Safety Defect and Noncompliance Report Guide for Vehicles
PART 573 Defect and Noncompliance Responsibility and Reports¹

Re: GEN V EM-1 Evaporator Fuse Assembly
Recall #11E-003

TAC-SER11-001
01-31-11

Subject: EM1 Gen V Evaporator Units

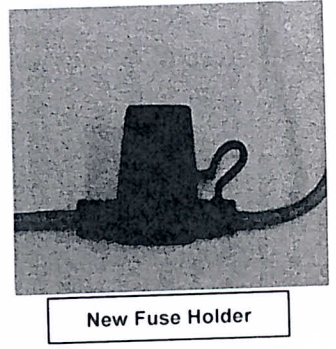
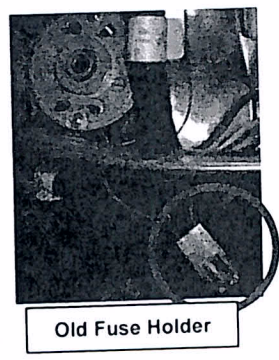
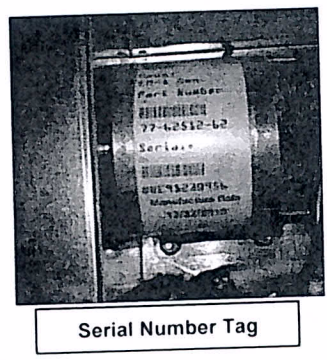
- 1) Remove the cover from the evaporator by removing the 8 screws shown below. Properly support the cover while removing the screws.

- 2) Once the cover has been removed, the identification tag containing the unit part number, manufacture date, and serial number can be found on the motor "cradle" mount, as seen in the photo below (on left). Compare the information to the above mentioned manufacture date, and/or serial number. Units employing a fuse holder as appears circled in red below require the upgrade with the new fuse holder.

The EM1 GenV blower motor fuse assembly could fail in an unsafe manner, creating a potential fire hazard. We are advising that any units manufactured between January 1, 2006 and December 2010 must have the evaporator motor in-line fuse assembly upgraded with the retrofit kit 74-62056-00. The only units affected are EM1 GenV evaporator modules, part numbers 77-62512-XX and 77-62112-XX, with serial numbers between KNT90890232 and NNE91230058. Customers with EM1 GenV units prior to the above mentioned serial numbers and dates that have had Carrier replacement motors 54-00621-00 installed, will also require this upgrade.
